Department of Planning, Housing, & Community Development

Date: 19 August 2013
To: Commission on Architecture & Urban Design Members
Subject: **33 Oak Street – Window**
Tax ID: 160.55-2-24
Case: CAUD 2013-28
Copies: T. Costello; C. Fenson; file

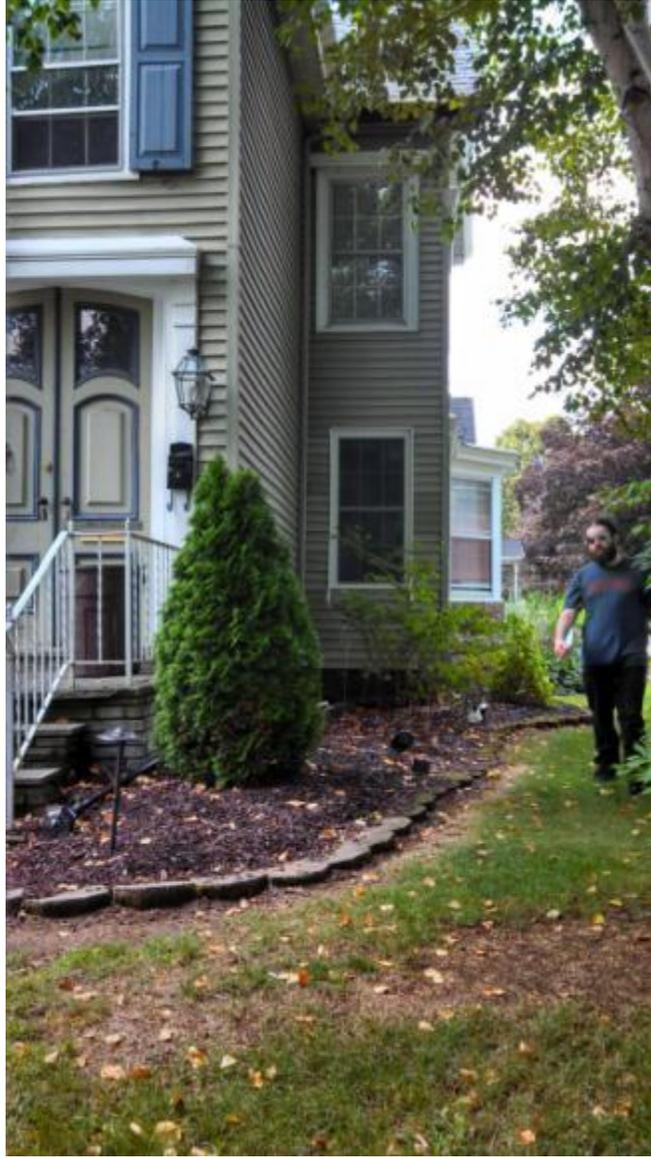
The window as installed, however, was not done in an appropriate manner. The window was not installed in line with the window on the upper floor, and the window which was installed is not the same width as the window on the upper floor (see the August 13, 2013, photograph).

Detail of 13 August 2013 photograph – notice the lack of alignment between the two windows; the red lines are drawn along the sash frame of the upper window

1. That the new window be the same width and height as the existing window on the upper story;
2. That the new window be installed to line up with the existing window on the upper story; and
3. That the new window be trimmed out to match the existing window on the upper story.
